2210899

**Response to Request for Additional Information –SSD-67895459-MOD-4
106 & 120-122 Smith St And 3a Charlotte St, Wollongong
Shop Top Housing with In-fill Affordable Housing**

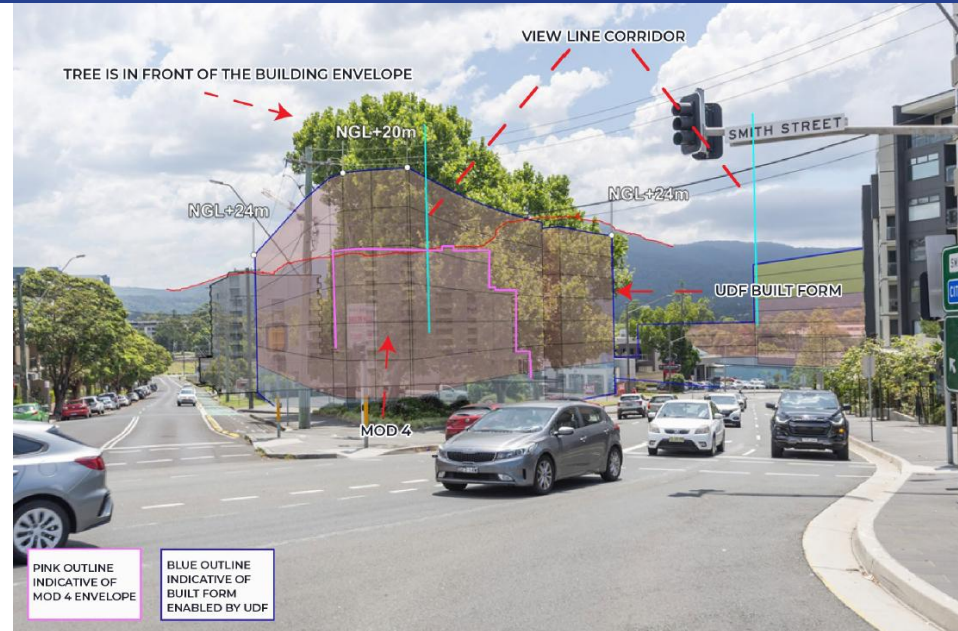
It is the findings of this report that the proposed modification would be visually blocked in its entirety by potential future development of the corner site when viewed from the corner of Smith and Flinders Streets as demonstrated in the below photomontage.

The additional floors proposed in MOD 4 will not be visible from the UDF viewpoint in the future Flinders Street Precinct context or the existing controls which permit up to 24m buildings. This remains the case even if future buildings do not receive a 30% AH bonus and stay below the 24m view cone height, which aligns with the existing height limit. Furthermore, future context buildings are positioned behind an existing cluster of mature trees, which fully obscures the proposal from the UDF view corridor.
